6.0 A Way Forward

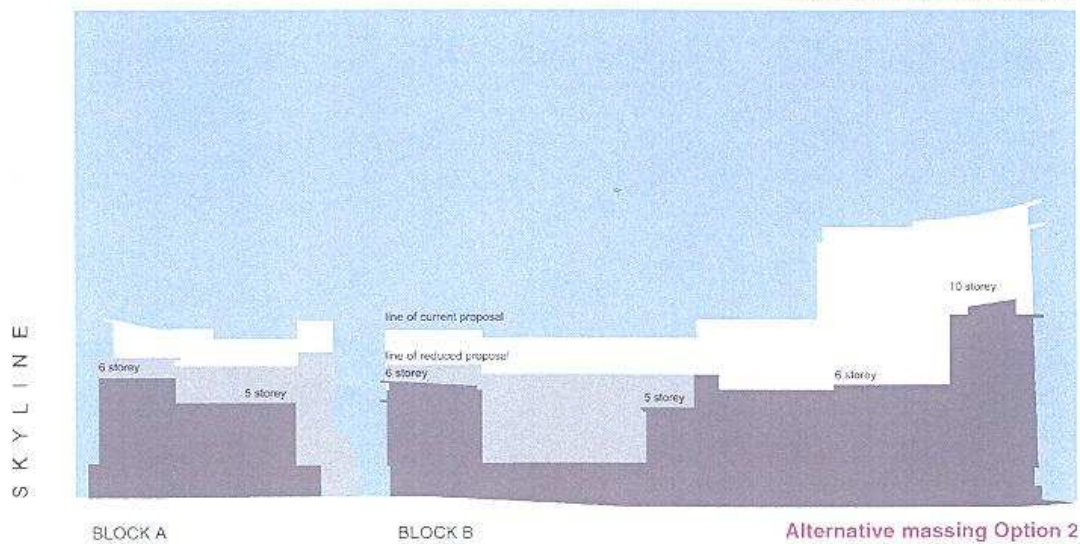
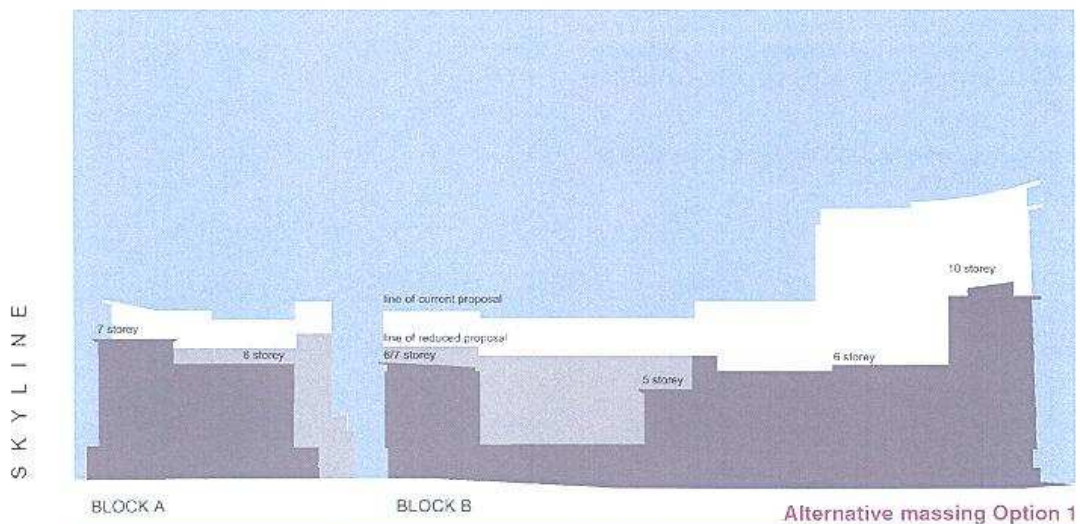
- i) The building mass and scale must be reduced. A more varied roofline should be sought to reduce the bulk of the buildings and generally refine the building silhouette. The tower feature should be slimmed down to accentuate its proportions and the height should be reduced to ten storeys to fit in better with the immediate context. Other elements of the scheme should be reduced to five and six storeys (perhaps rising to seven along the front of Block A).
